From: Andrews, David
Sent: Wednesday, March 17, 2010 1:39 PM
To: 'Gurmendi, Aldo R.'; 'Rig302'; 'dsmith@bjsservices.com'; Keidel, Jannette E.
Cc: 'Schmitz, Steve H.'; Longworth, Mike; 'Shaun.Keller@state.co.us'; King, Kevin; Krabacher, Jay; Yokley, Bill
Subject: RE: Sidetrack option
Attachments: SIDE TRACK Guidance Document Rev. 09-29-2009.pdf; Sidetrack Plan and Documentation.pdf

**BERRY PETROLEUM COMPANY
 PICEANCE BASIN - COLORADO
 GARFIELD, COUNTY
 CHEVRON 20-30D**

**Berry Petroleum Co
Chevron 20-30D**

Project: Garfield County
 Site: NWSE S20-T5S-R96W (Chevron J20 596)
 Well: Chevron 20-30D (J20 596 Pad)
 Wellbore: Stk
 Design: Plan #1

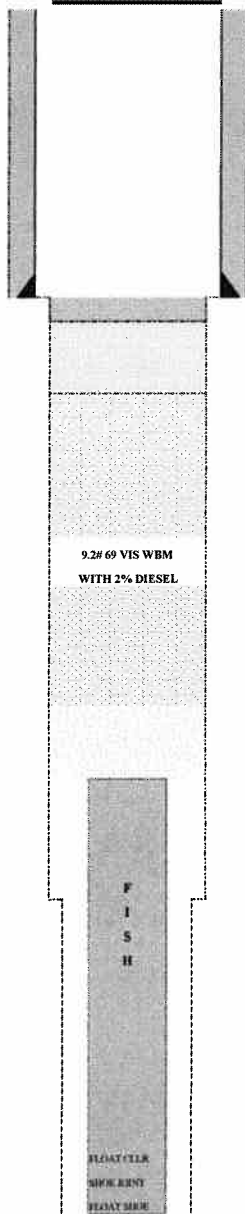
With regard to the plug back, two plugs will suffice, considering that the TOF (6490') is above the Ohio Creek prog top. Set Plug #1 above the TOF and Plug #2 for the kick off.

Please reply with the API Number for this well, the depth to top of gas, and formation log tops. At a minimum, you will have to set Plug #1 above top of fish, Plug #2 above top of Williams Fork Formation, and Plug #3 kick-off plug. Please "reply to all" with your proposed cement volumes, yields, slurry weights, depths, and plug lengths.

- Note: 9 5/8" 36# J55 surface casing is set to 2237' MD
- TIH and set plug #1 (100' of 13.2# of top of fish plug).
- POOH to 3037' MD and set plug #2 (600' of 12.5# balanced plug).
- POOH and let cement set for 12 hours.
- TIH and dress off plug #2 down to 2637' MD
- POOH, L/D drill bit and heavy pipe
- TIH open-ended and set plug #3 (400' of 17.0# heavy cement KOP plug).
- POOH and let plug set for 24 hours
- TIH dress plug 100' and timedrill off cement plug, sidetrack hole ~ 2298' MD
- POOH for new directional BHA, drill to TD.
